From: Euan Clark - Folkes Architects [REDACTED]
Sent: 25 November 2019 16:48
To: Anita Gardner <Anita.Gardner@arun.gov.uk>
Subject: FW: 10053: Toddington Lane Littlehampton, Arun District, BN17 7PN APP/C3810/W/18/3197149 (LU/162/17/PL) Condition 14

Subject: 10053: Toddington Lane Littlehampton, Arun District, BN17 7PN APP/C3810/W/18/3197149
(LU/162/17/PL) Condition 14

SECTION 278 AGREEMENT PLAN GENERAL ARRANGEMENT

Drawing Number
10053_300

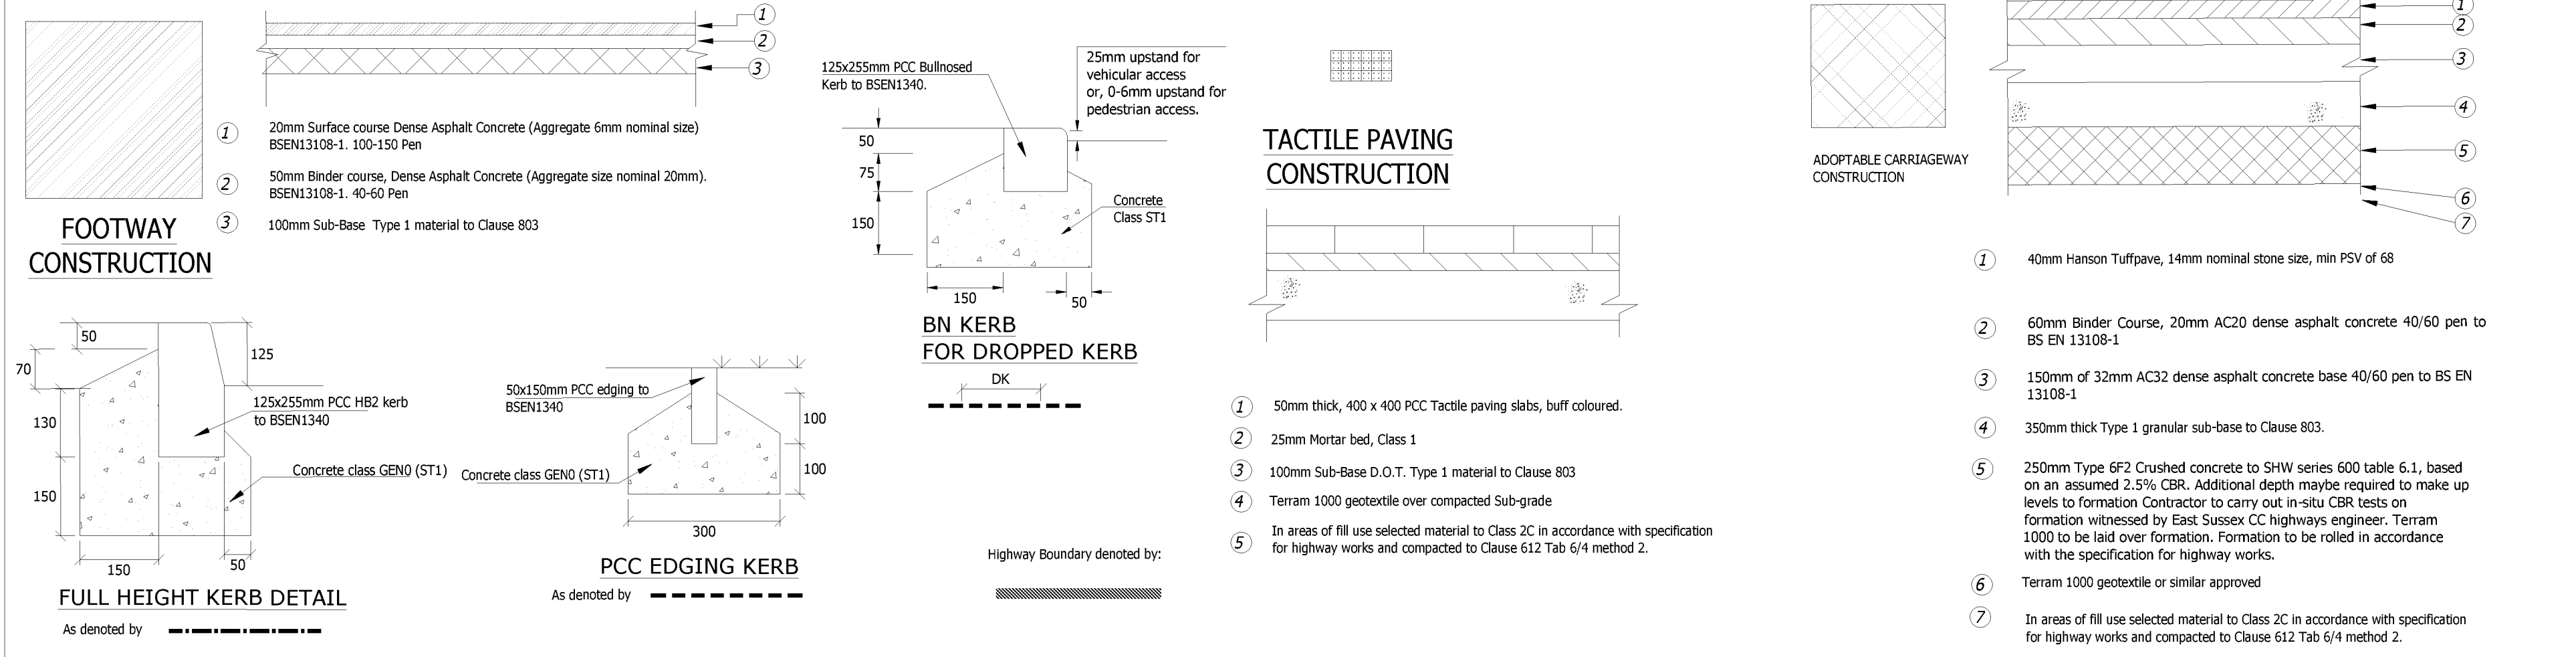
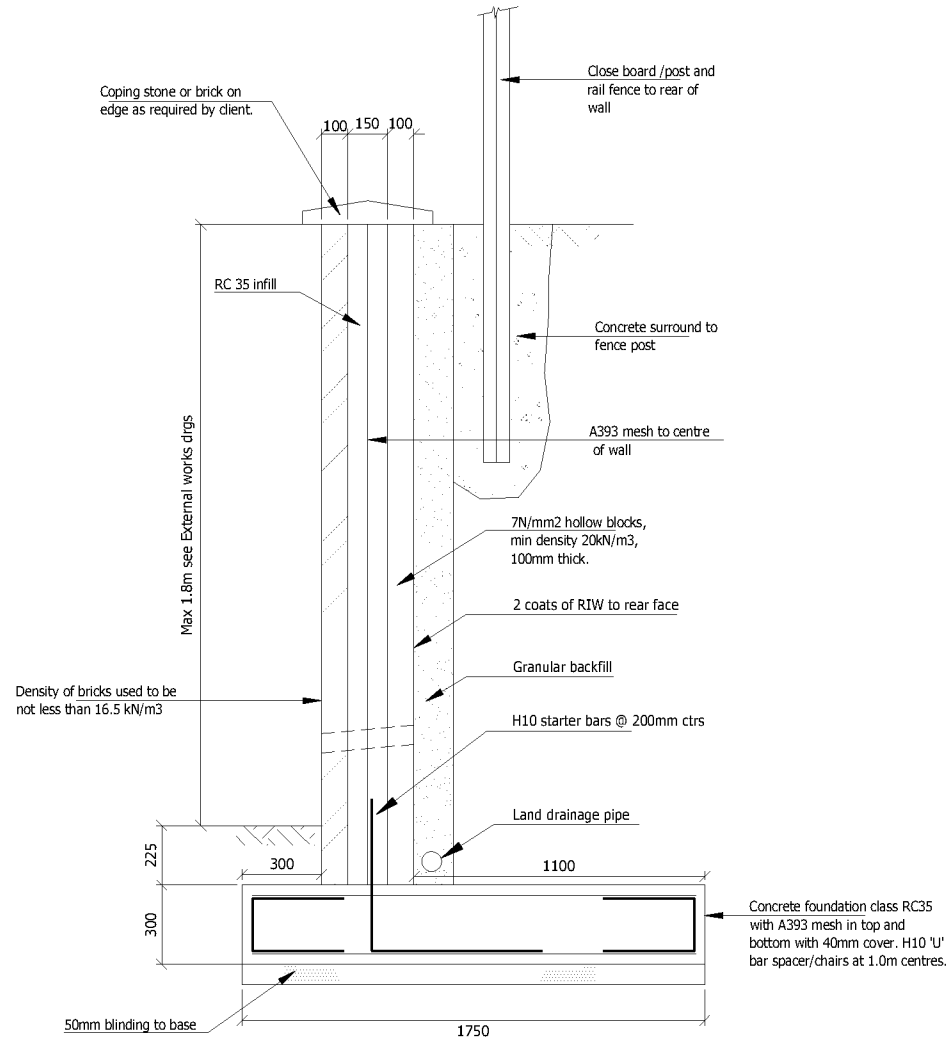
I am contacting you in regards to the development at Toddington Lane (LU/162/17/PL) and condition 14. In your comments on 15th October 2019 you asked for A visibility splay of 2.0m * 66m in both directions at the western end of the proposed footway. This was to ensure any pedestrians crossing in this location have sufficient visibility to see any oncoming cars. The 66m visibility splay is achievable looking west but not looking east.

I note that section 4 of WSCC design guide states that lightly trafficked residential roads have 85thile speeds below 37mph, can have MfS1 standards applied. As this is the case for Toddington Lane, the 66m visibility splay is likely in excess of the stopping sight distance for westbound vehicles will need to see pedestrians. Using MfS1 standards and the recorded 28mph 85thile speed there is a stopping sight distance requirement of 39m.

I also note that the visibility splay asked for is from 2.0m, the proposed footway is 2m in width and it is unlikely a pedestrian would be stood on the back edge of the footway, would a visibility splay from 1.0m be acceptable as this is likely to be more reflective of a pedestrians position on the footway.

With the above in mind I would suggest a 1.0m * 39m visibility splay should be acceptable and allow for the crossing point to function safely. Please see update site layout with the visibility splays, I have shown 66m looking westwards as this is achievable and 39m is achievable looking east. Please note I have shown the 39m visibility splay to 600mm off of the kerb to represent the likely position of a car.

Would the proposed visibility splay be suitable?

A	PEDESTRIAN VISIBILITY SPLAY REVISED	19.11.2019	ART	LS
-	INITIAL ISSUE	25.09.2019	ART	LS
Rev	Amendments	Date	Dsn	Chk
